List of part numbers affected: Type 8843.ZP30

2 Type of change

| Engineering Documentation | | | | | PCN 8843.ZP30 | | |

| Old product appearance 8843.ZP30 | New product appearance 8843.ZP30 |

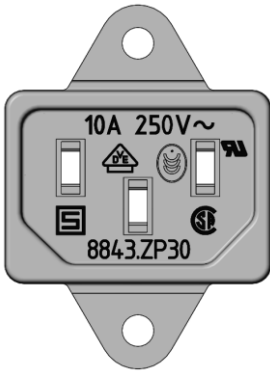
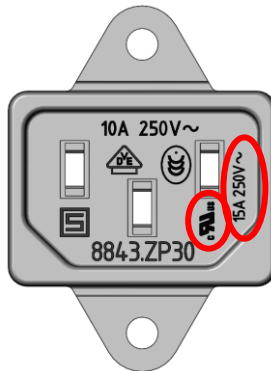
- Standards update and modification of approval marks.

| Old product appearance 8843.ZP30 | New product appearance 8843.ZP30 |
|---|--|
| Old product rating 10A 250VAC | New product rating 10A 250VAC for VDE and CCC 15A 250VAC for UL/CSA |
| Old product approval UL and CSA mark | New product approval Combined UL/CSA approval according to UL 60320-1 |

| Old product appearance 8843.ZP30 | New product appearance 8843.ZP30 |
|---|--|
| Old Label | New Label |

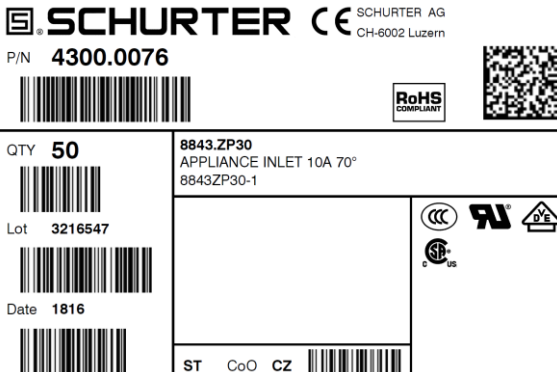
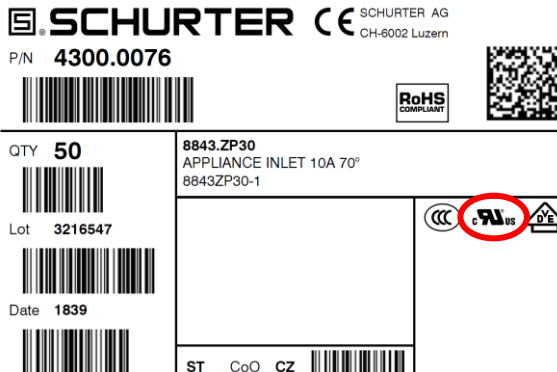
| Form | Yes | Replacement of UR and CSA mark with combined cURus mark. |
| Label | Yes | Replacement of UR and CSA mark with combined cURus mark. |
